SUBJECT: Forwards draft proposed FSAR changes, including revs to steam
 supply logic & recirculation flow path for auxiliary
 feedwater sys to correct nuclear cooling water sys
 flowrates.Changes will be incorporated in FSAR Amend 14. *56.6 rpt*

Enclosed for your information are draft proposed FSAR changes. These changes 1) identify the presence of essential HVAC to cool the essential spray pond pumphouse, 2) revise the steam supply logic and recirculation flow path for the auxiliary feedwater system (Reference 1 and 2), 3) correct nuclear cooling water system flowrates, 4) clarifies the closure time of the main steam stop valves, 5) update the listing of safe shutdown equipment in accordance with the spurious actuation analysis submitted in Reference 3, 6) delete the letdown line low flow alarm, and make editorial corrections and clarifications. These changes are considered acceptable as 1) the essential HVAC meets design criteria as described in section 3.2, 2) the auxiliary feedwater system changes are consistent with CESSAR safety analyses, 3) the nuclear cooling water flowrates meet design requirements, 4) the revised closure time of the stop valves is consistent with the man

FIG 9B-41

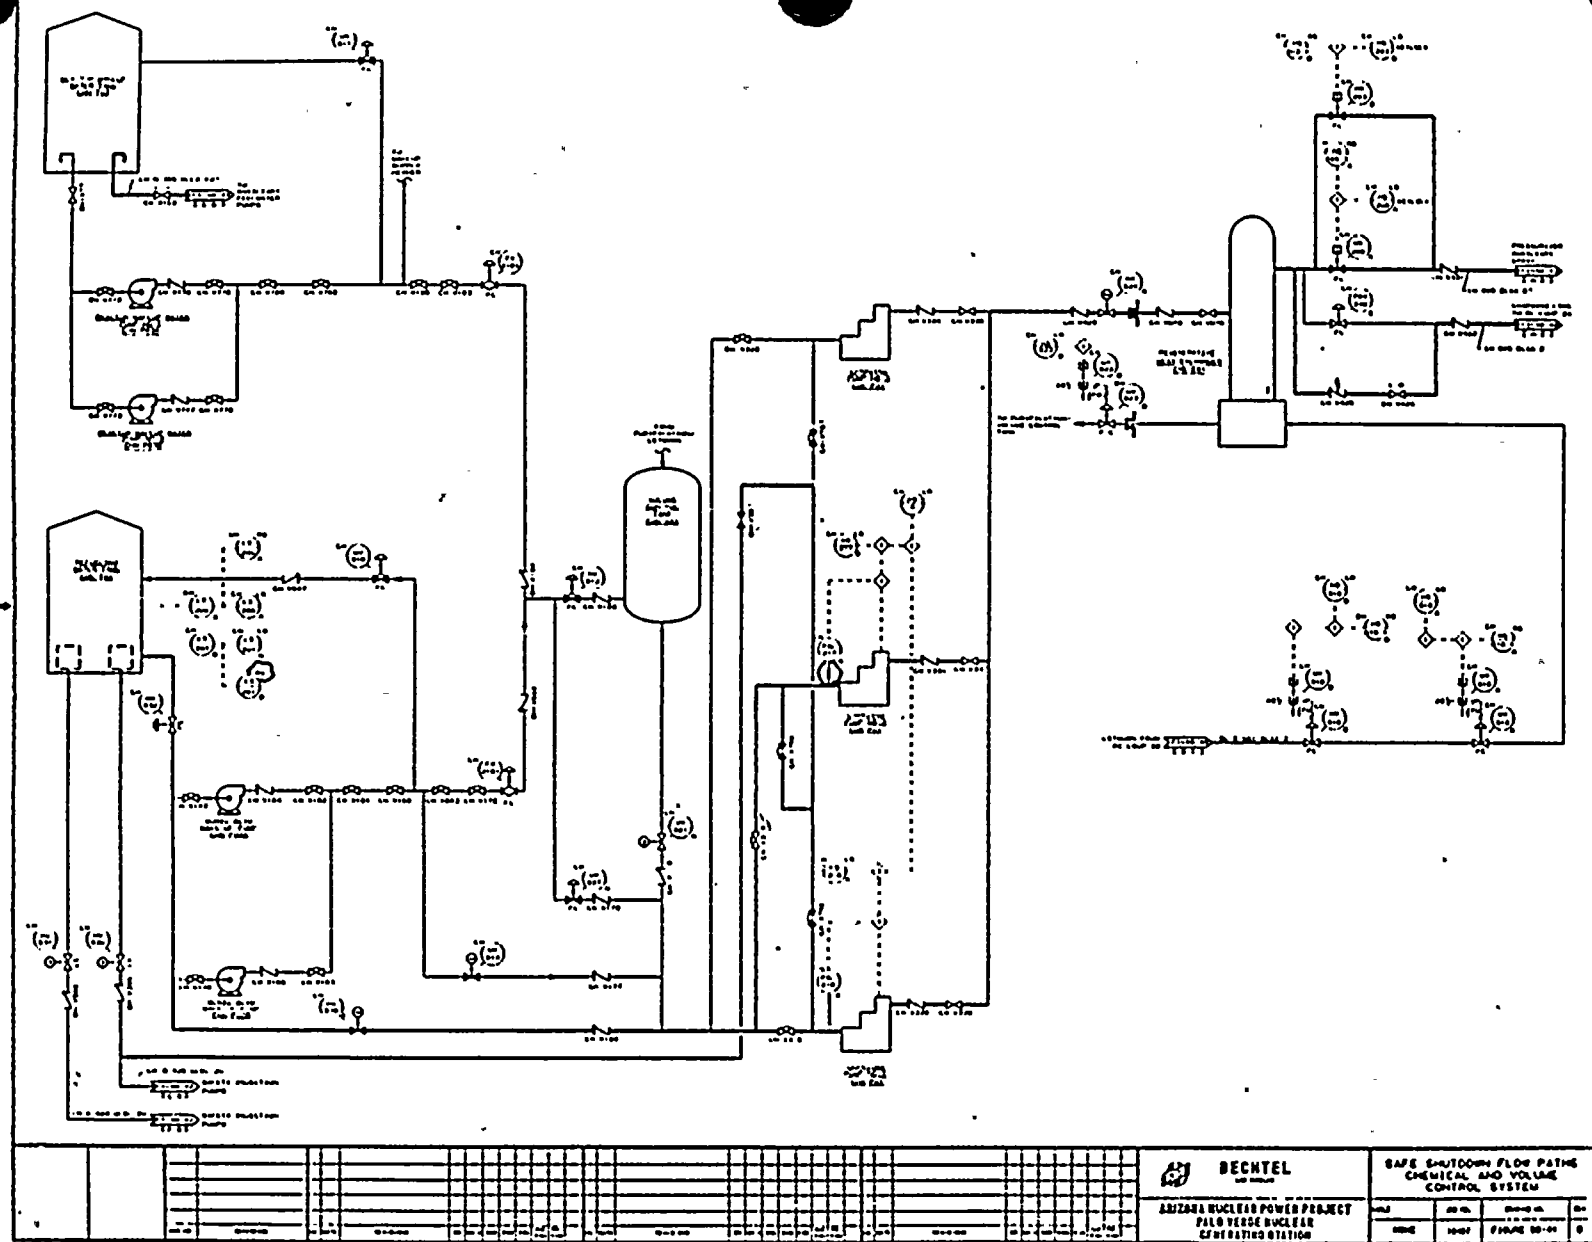
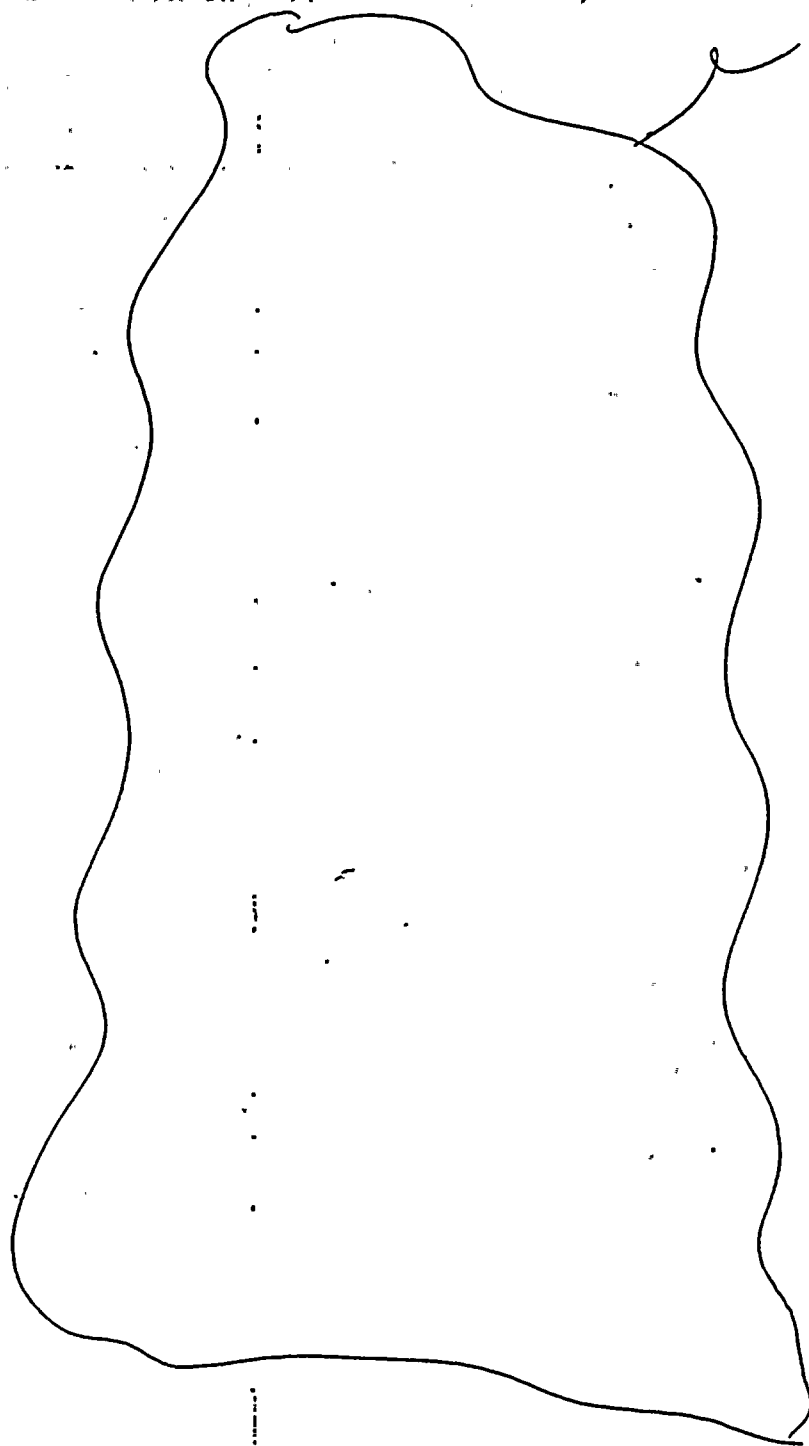
REPLACE
W/ ATTACHED
FIG 9B-41

CHANGE

FIG 98-43
(Sht 1 of 2)

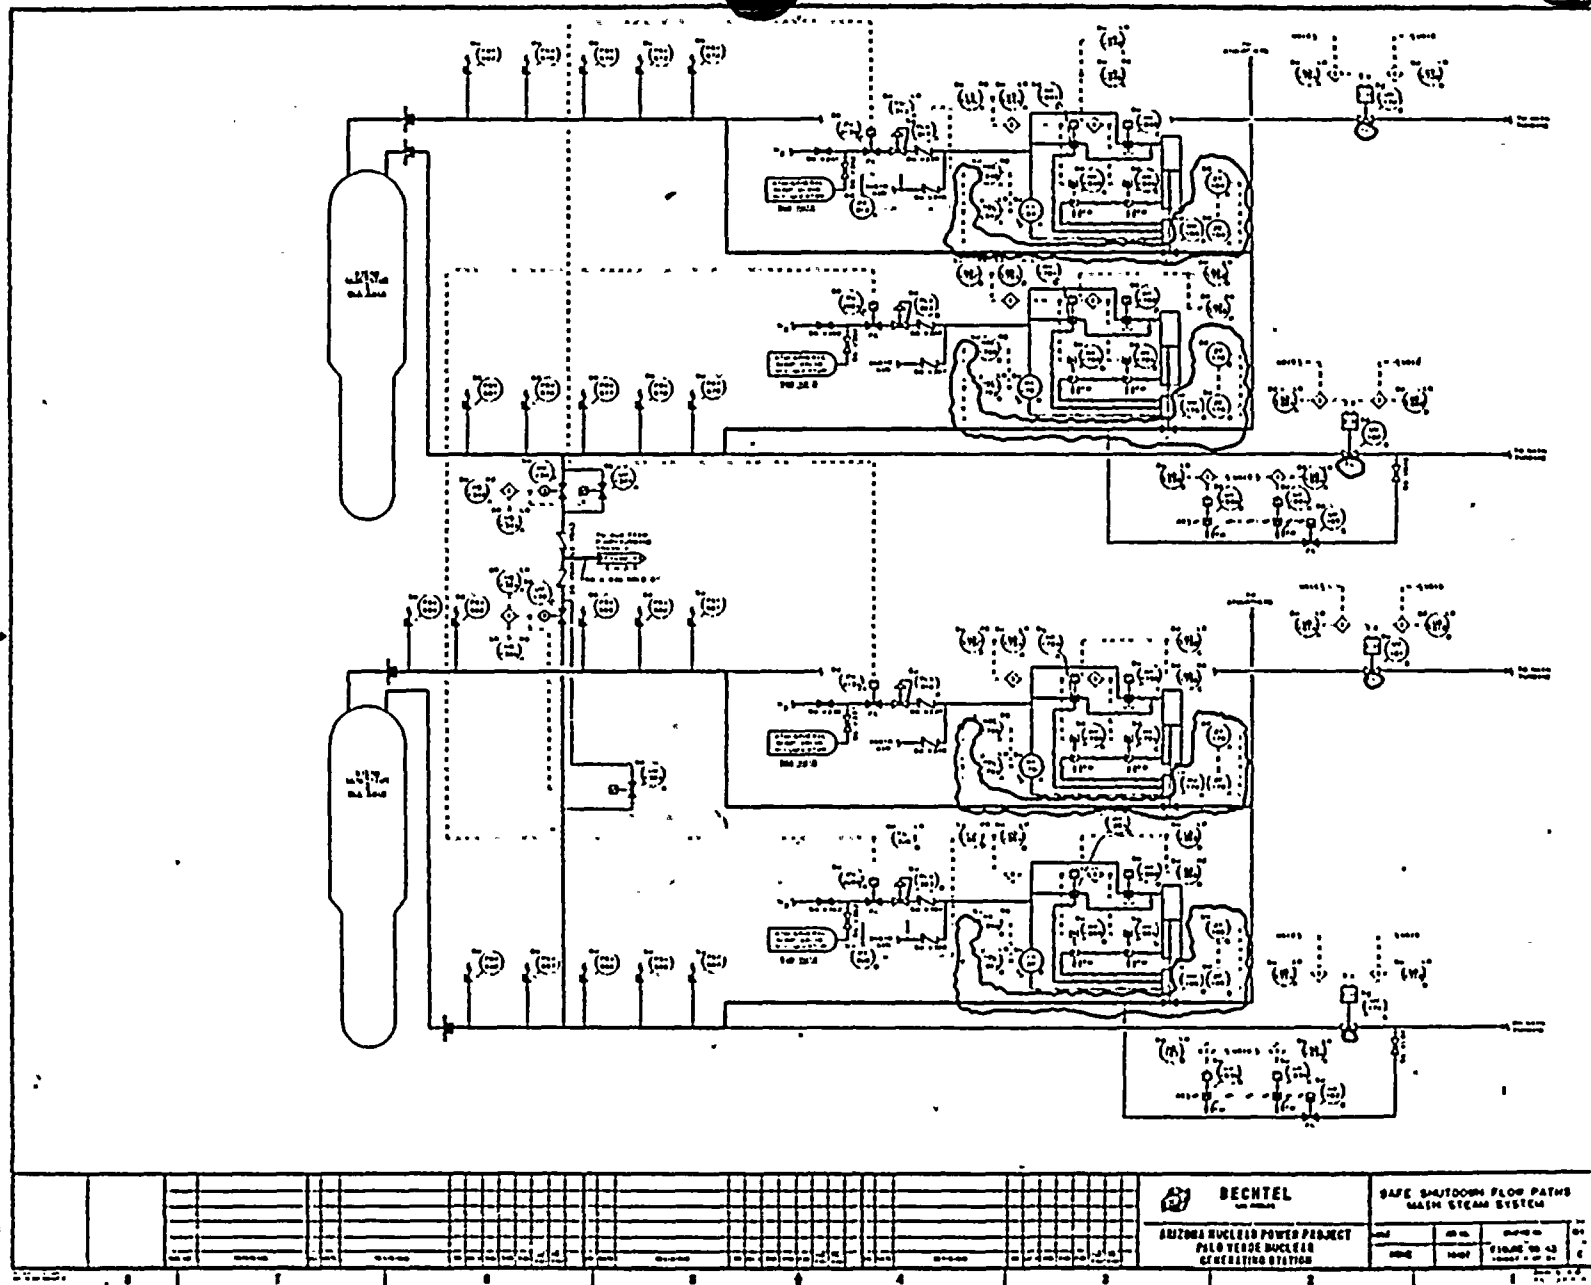
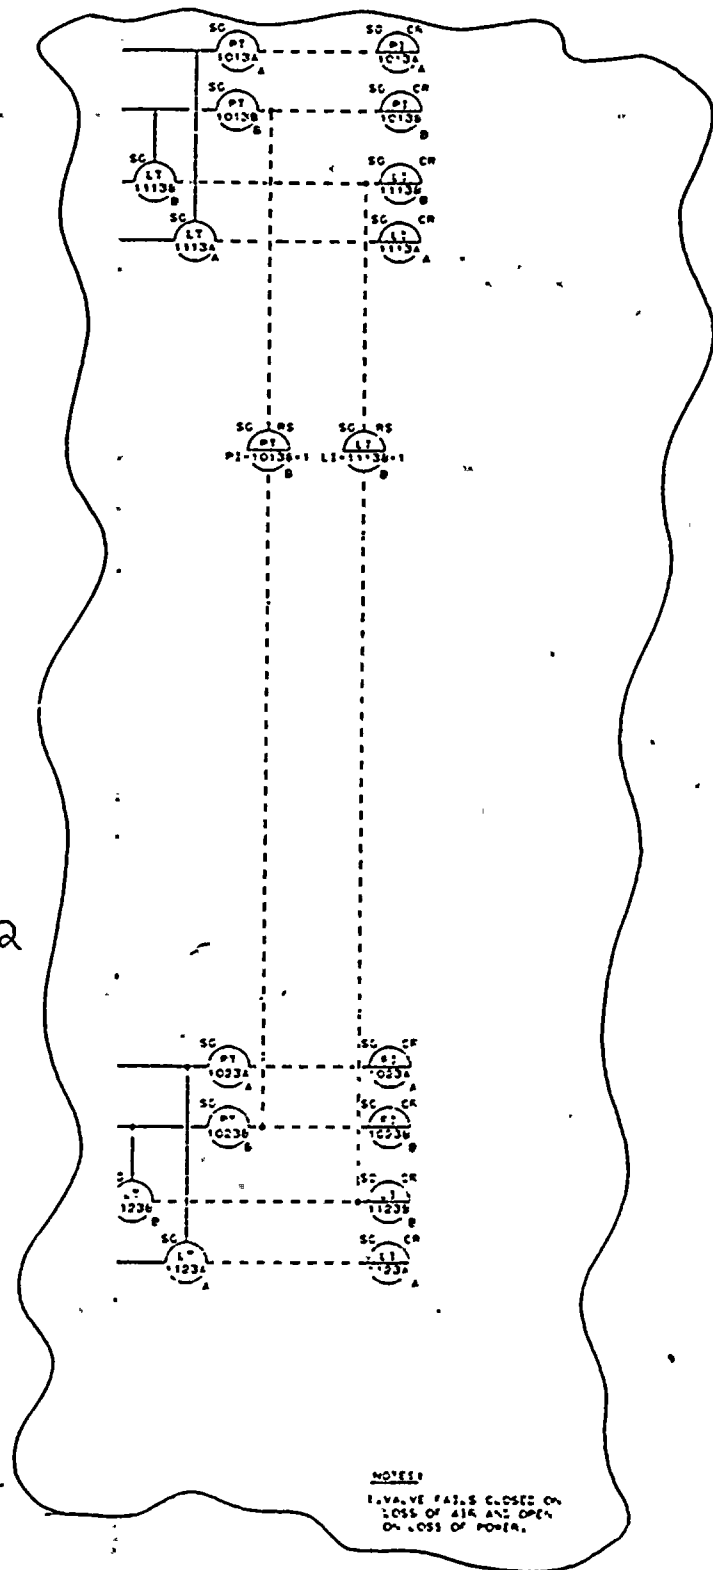
REPLACE
W/ ATTACHED

CHANGE

FIG 9B-43
(sht 2/2)

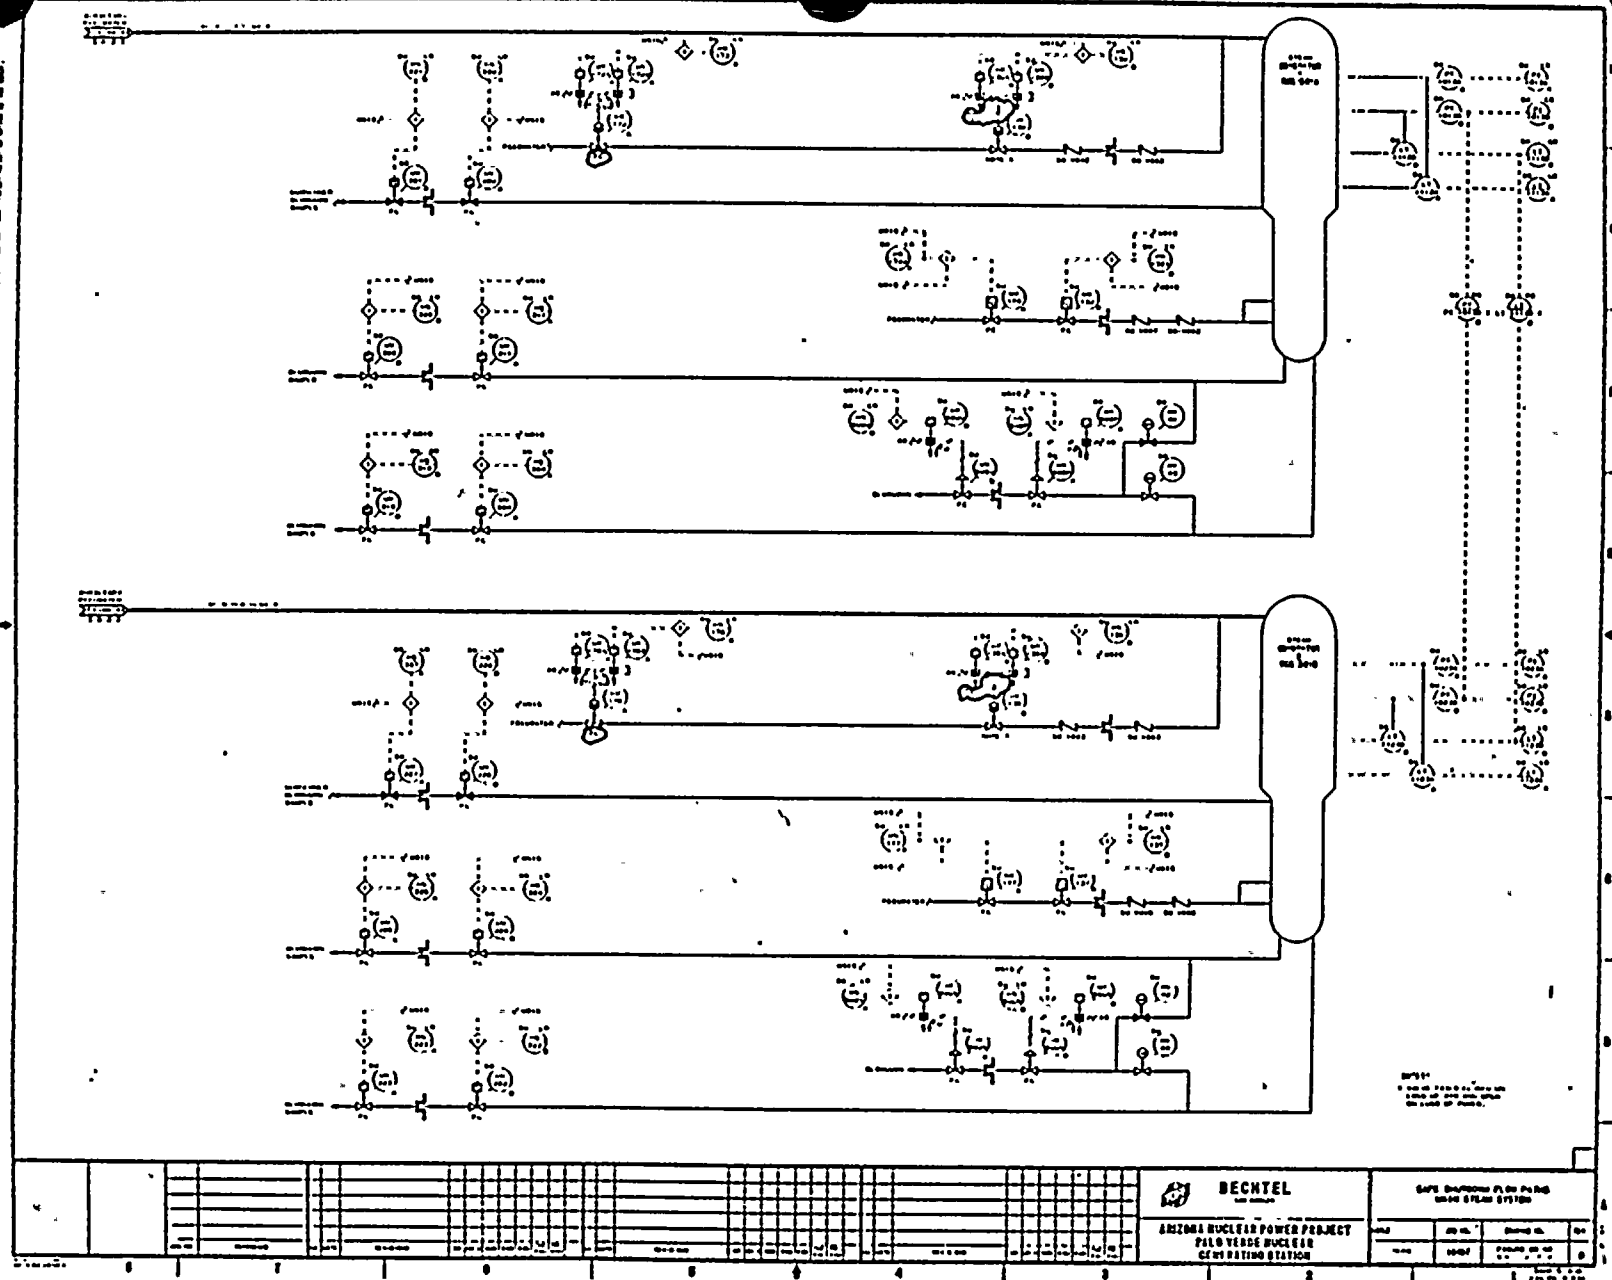
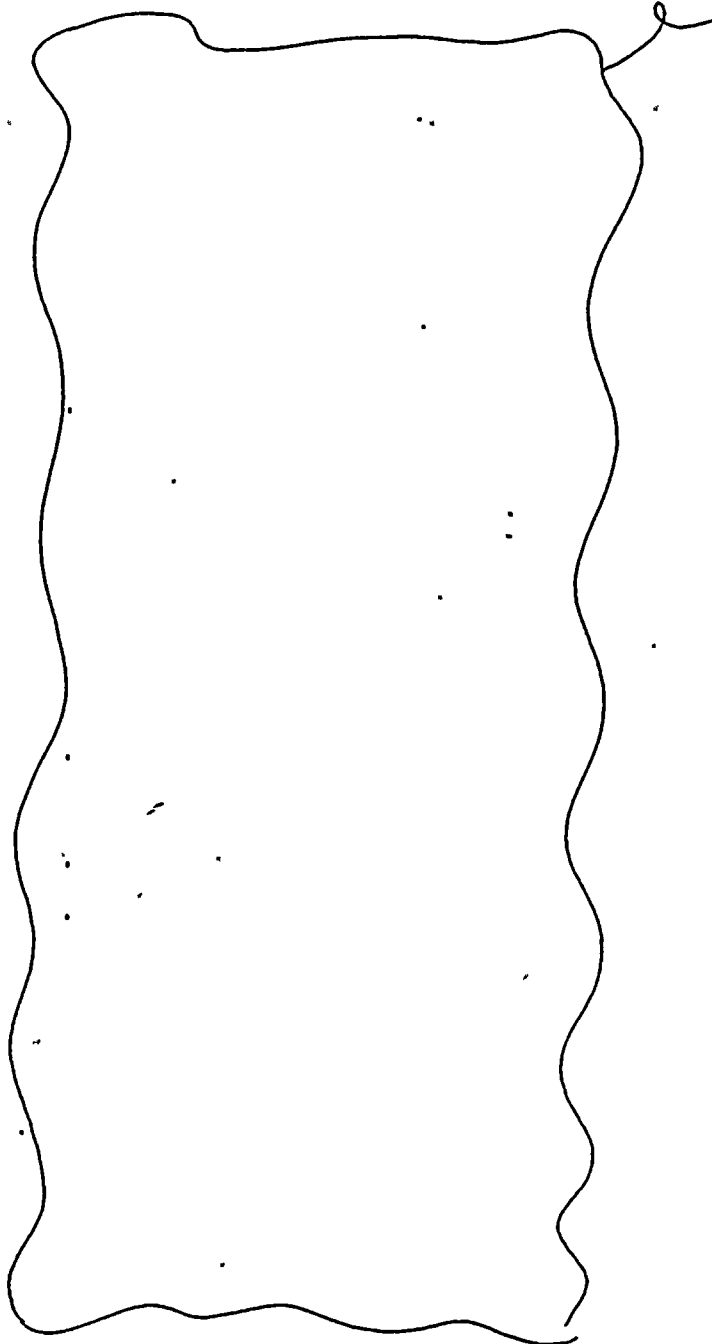
REPLACE WITH
ATTACHED
FIG. 9B-43 sheet 2/2

CHANGE
